May 15, 2002

**Contract:** N62474-98-D-2076, Environmental Remedial Action Contract

**Contract Task Order:** 0060, Installation Restoration Sites 4 and 5, DNAPL and Dissolved Source Removal Action

**Subject:** **Amendment to the Final Removal Action Project Plan  
Installation Restoration Sites 4 and 5  
DNAPL and Dissolved Source Removal Action  
Alameda Point, Alameda, California, February 8, 2002  
Concerning Installation of Well Points for DNAPL Extraction at  
Plume 5-1, East of Building 5**

FIGURE 3

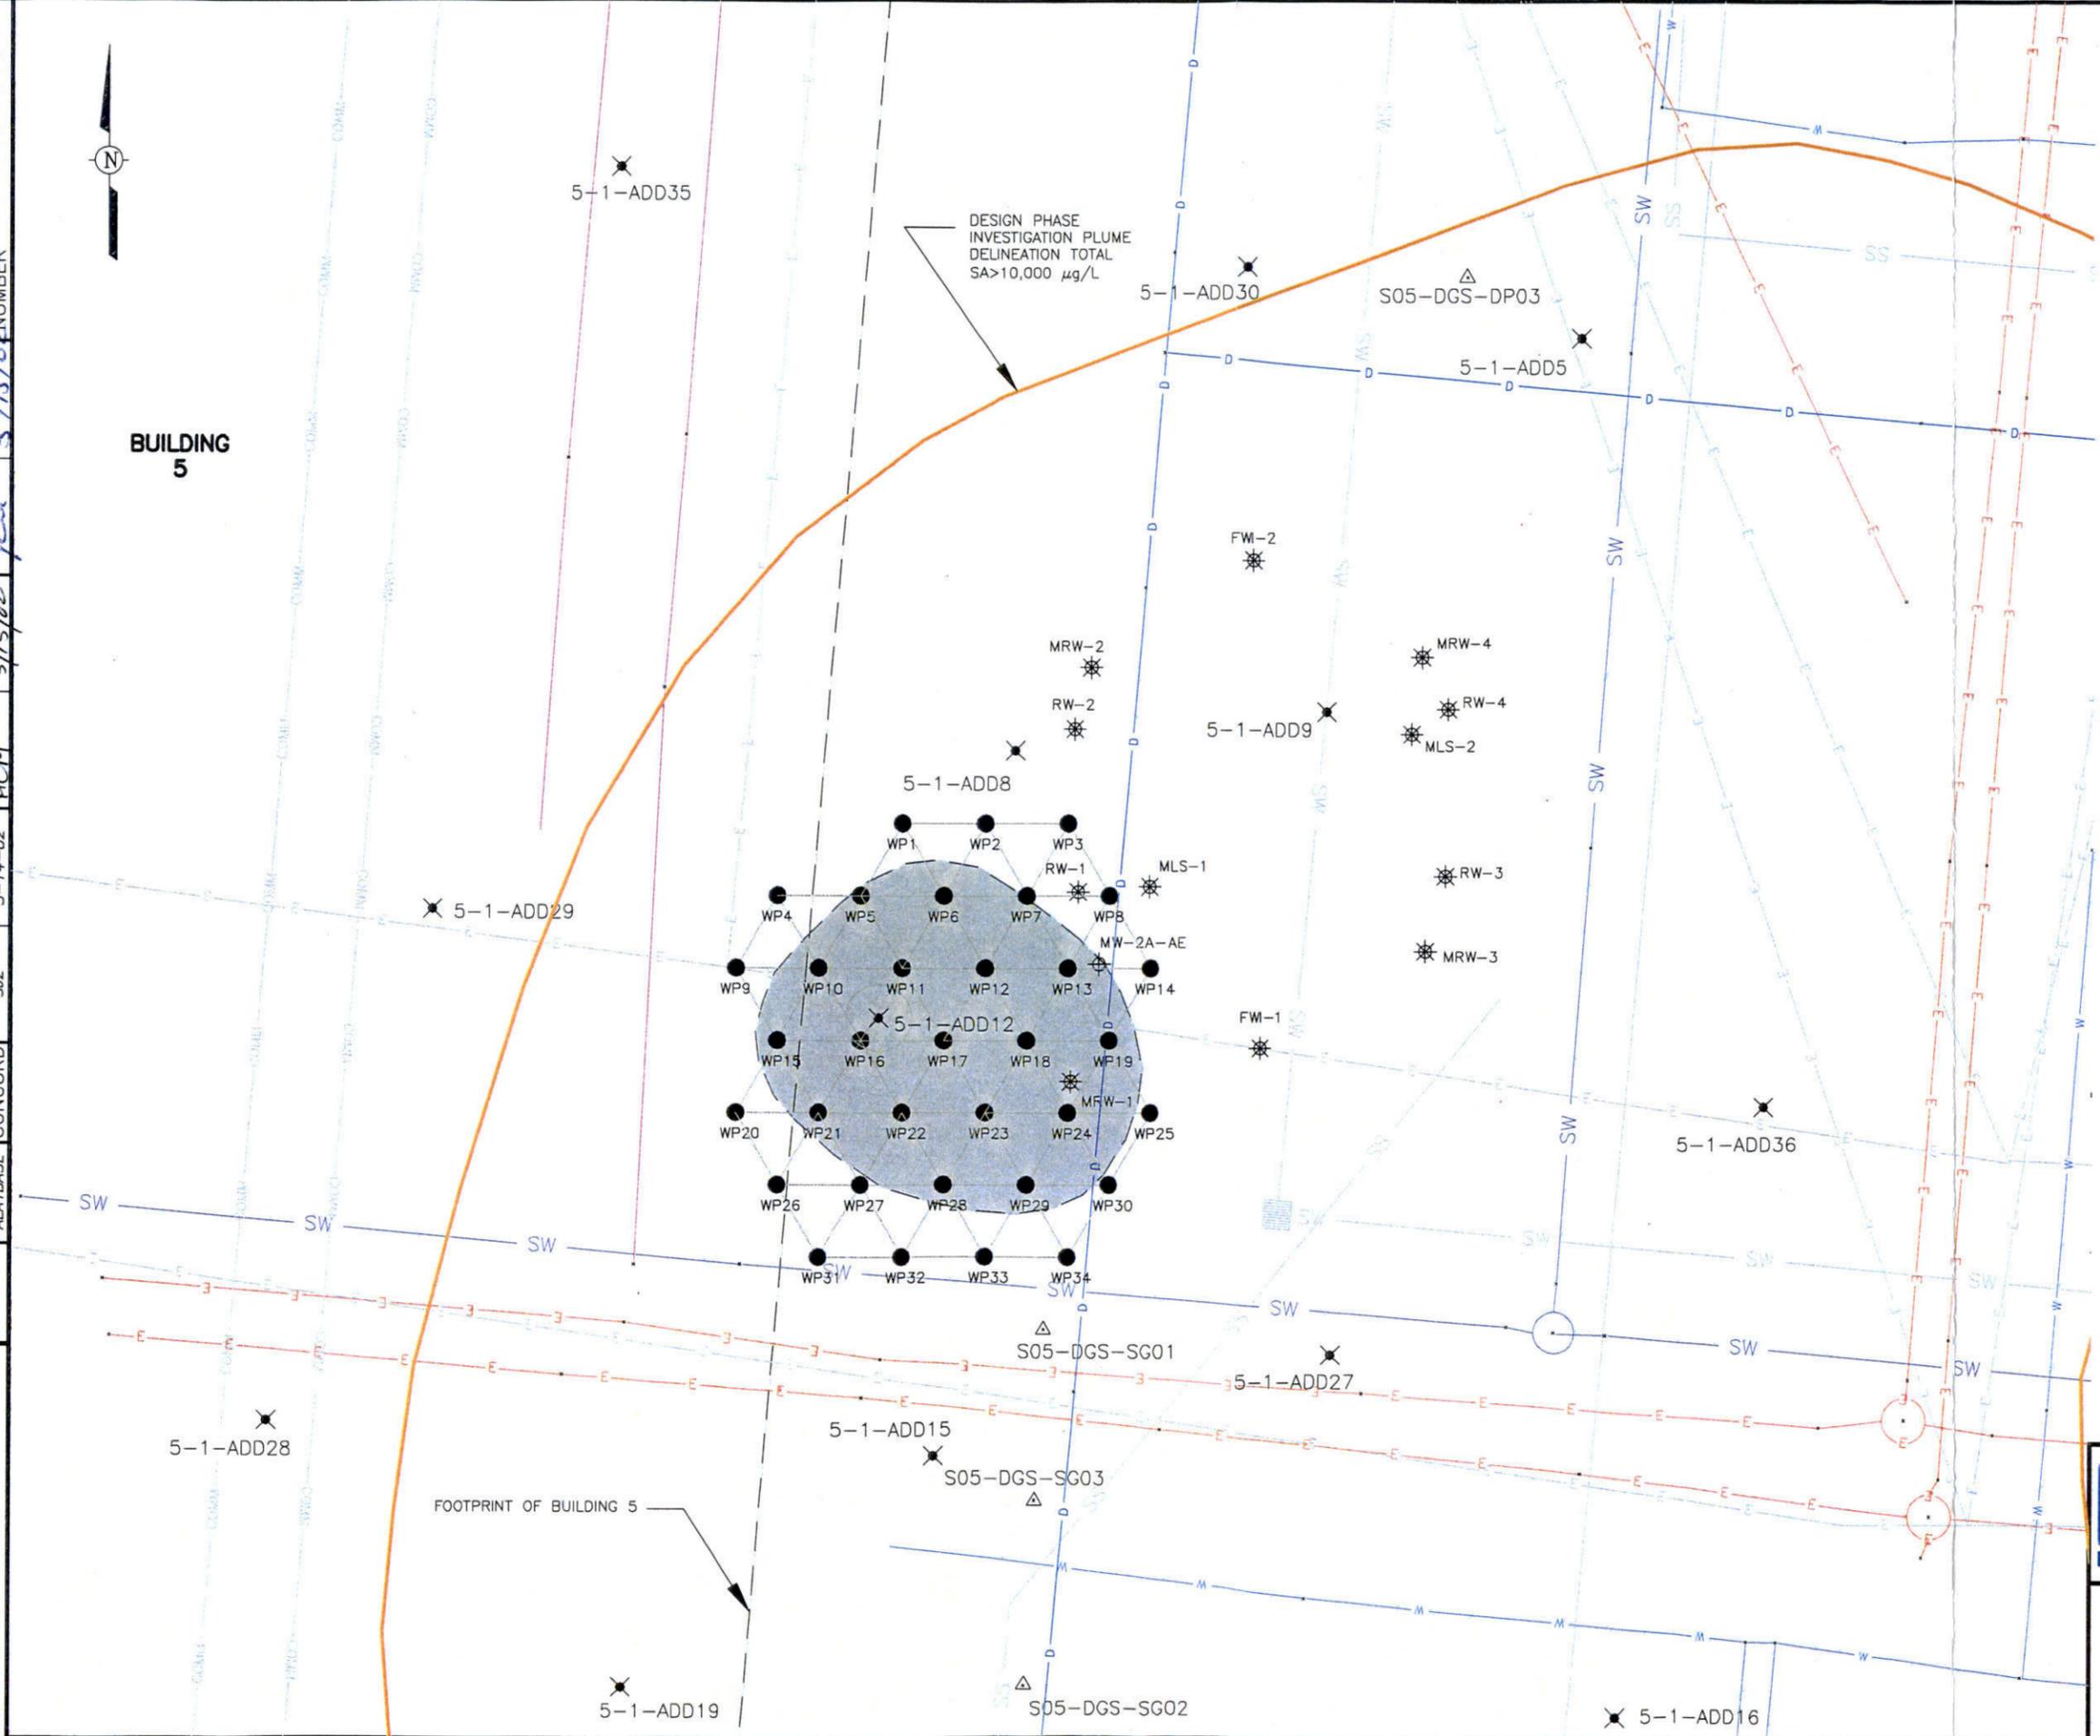
IT Corporation (IT) plans to install a DNAPL extraction array at Installation Restoration Site 5. The array was designed to cover the suspected lateral extent of mobile DNAPL and the individual temporary well points will be narrowly screened to target the soil horizon where the mobile DNAPL was found. The array will be comprised of 34 well points spaced on approximately 5-foot centers. The well points will have 3-foot long screens placed approximately 44 feet bgs. Figure 3 shows the well point locations and Figure 4 shows a typical well point schematic diagram. IT will use direct push technology to install the well points.

FIGURE 4

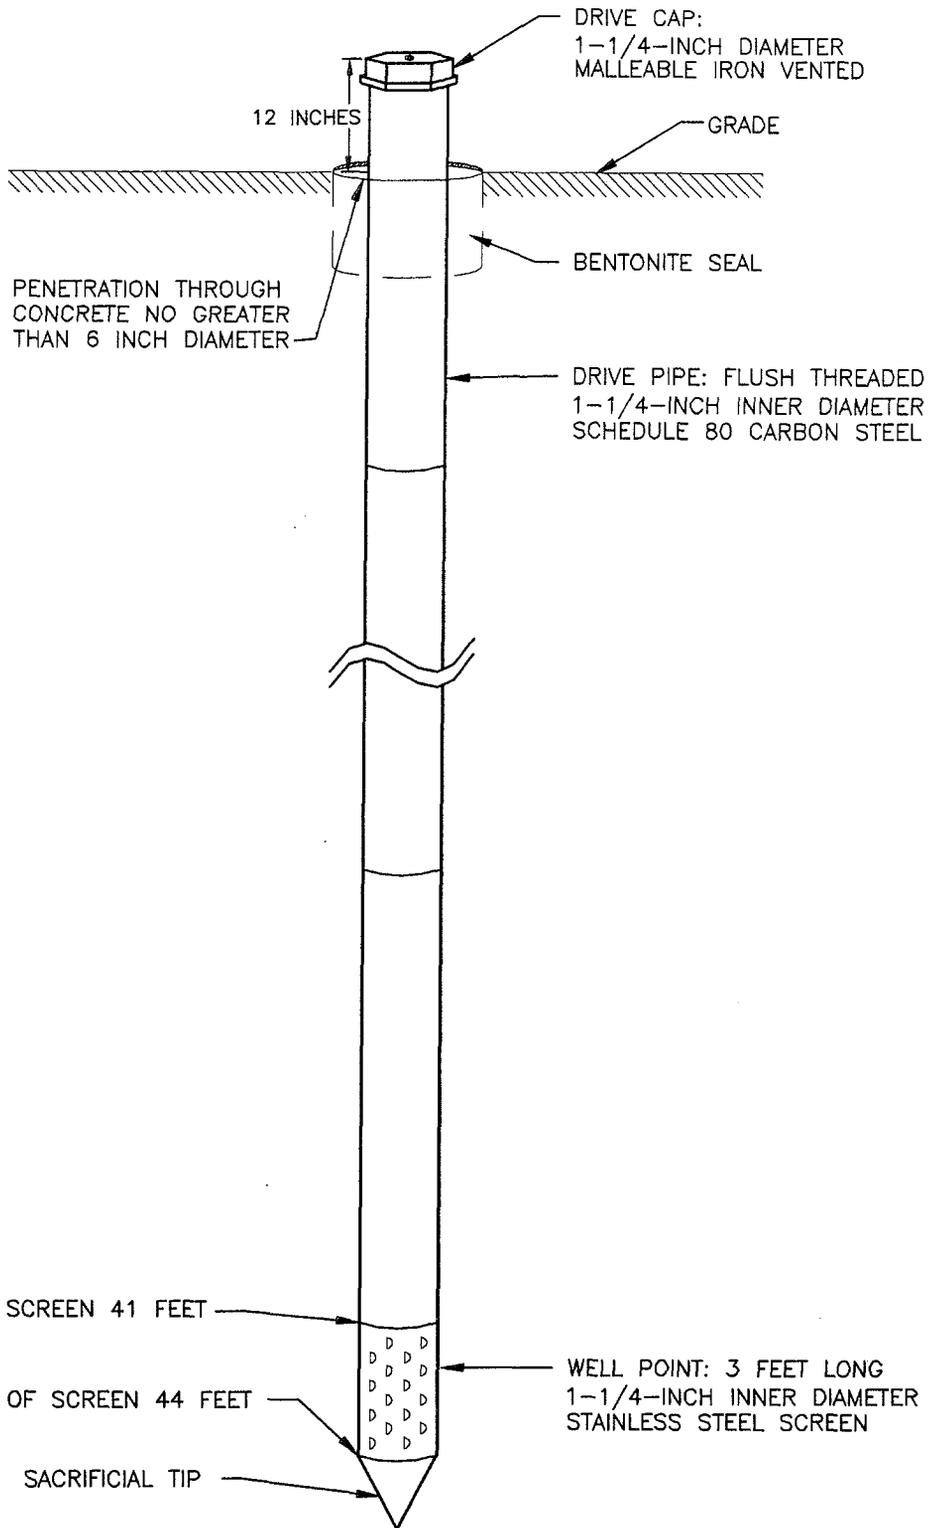
IT will abandon the well points by using the drive pipe and screen as a tremie pipe for thin (3 to 1) neat cement grout. Once the drive pipe is filled with cement slurry, the drive pipe will be slowly withdrawn, the sacrificial tip will stay in place at 44 feet bgs. Neat cement will backfill the void resulting from the drive pipe removal.
